BP Makes a fresh proposal for a Petrol Station and Food Outlet to the west of Udimore Road at TN31 6AA on a .6 Ha sit: February 2018

Reference	RR/2018/545/P
Status	Undecided
Proposal	Construction of petrol filling station, canopy, sales building, ATM, AC/refrigeration unites, refuse compound, parking and associated works.
Location	Udimore Road - Land North of, Rye TN31 6AA
Parish	RYE
Case Officer	Mr J McSweeney
Received	13-02-18
Validated	26-02-18
Decision By	28-05-18
Applicant	BP Oil UK Limited Witan Gate House Milton Keynes MK9 1ES
Agent	Aitchison Rafferty Attn: Mr Nigel Ozier The Granary Spring Hill Office Park Harborough Road, Pitsford, Northampton NN6 9AA

RR/2017/1231/P - Application for a petrol station and food outlet for land on Udimore Road: Refused by the LPA on 16 October 2017

Figure 1 Site plan under proposal

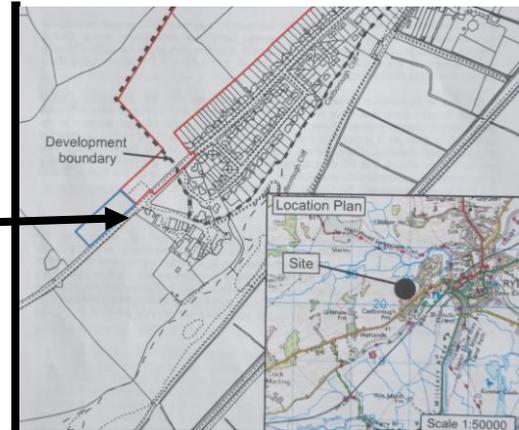
1. Aroncorps is developing the 10.87 hectare greenfield site known as Valley Park, initially approved for 135 dwellings, but subsequently increased to 165 in 5 phases. Around 4 hectares of the total site are being developed.
2. The development boundary (Figure 2) does not include an extension of the Aroncorps site on the west side of the roundabout, which rises to the high ground and the Rye Parish boundary. This site (Figure 1 – Red) is the subject of a further planning proposal.
3. The site sits to the north of one of the “gateways” to Rye from the West, close to the boundary of the AONB. In common with Valley Park, this site is a green space comprising mainly old pasture over clay. There is some old hard standing, formerly used for agricultural purposes. Drainage is complicated by springs, ponds and the impervious clay.

Figure 3 Proposal Plan

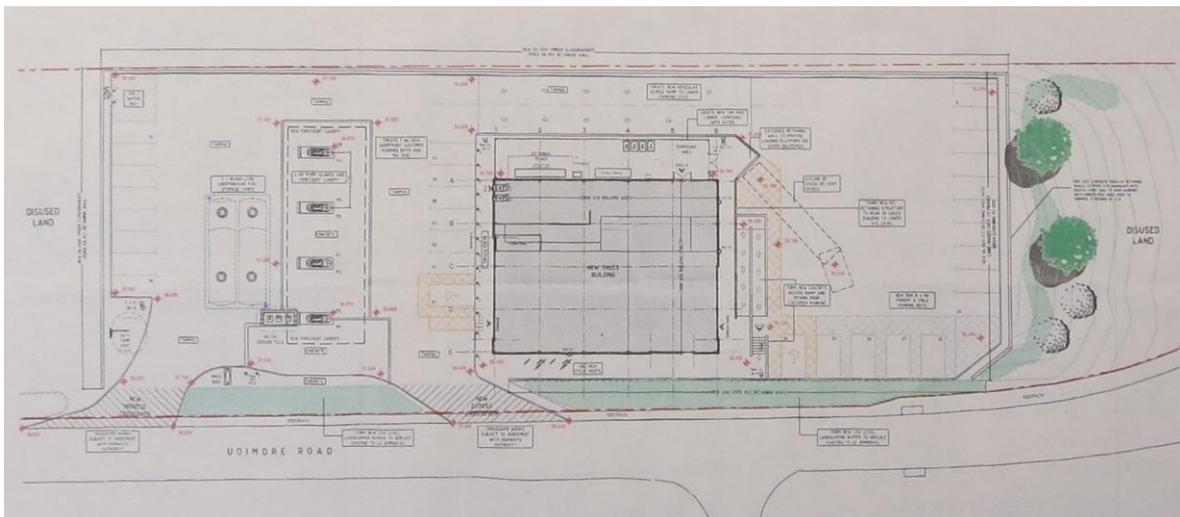
6. One reason for this opposition is that the RNP seeks to check development at the extremities of the Parish on sites just beyond or on the settlement boundary to ensure that the gateways to the Town are not adversely affected and that the unique character of Rye is preserved. There are several current proposals affecting other gateways in the Parish: Rye Hill (sites in Rye Foreign immediately adjacent the Parish Boundary), the tennis club on the Military Road and now this site. In addition there has for many years been informal development in the strategic gap to Rye Harbour. All this is seen to add “urban creep” into the green spaces surrounding Rye Parish, adversely impacting on the character of Rye and its place in the environment.

9. The 2008 argument by the Planning Inspector above is considered relevant, because it cannot be applied to this new proposal. Even with landscape and lighting mitigation, on such an elevated site, it would not *“be contained within the landscape and sit comfortably within the context of the adjoining development”*.

10. Rather, this proposal could be seen as further “urban creep” (both by structure, lighting and noise) that would impact adversely on one of the gateways into Rye and in turn on Rye’s unique character and profile in its marsh surroundings, including the adjacent AONB.
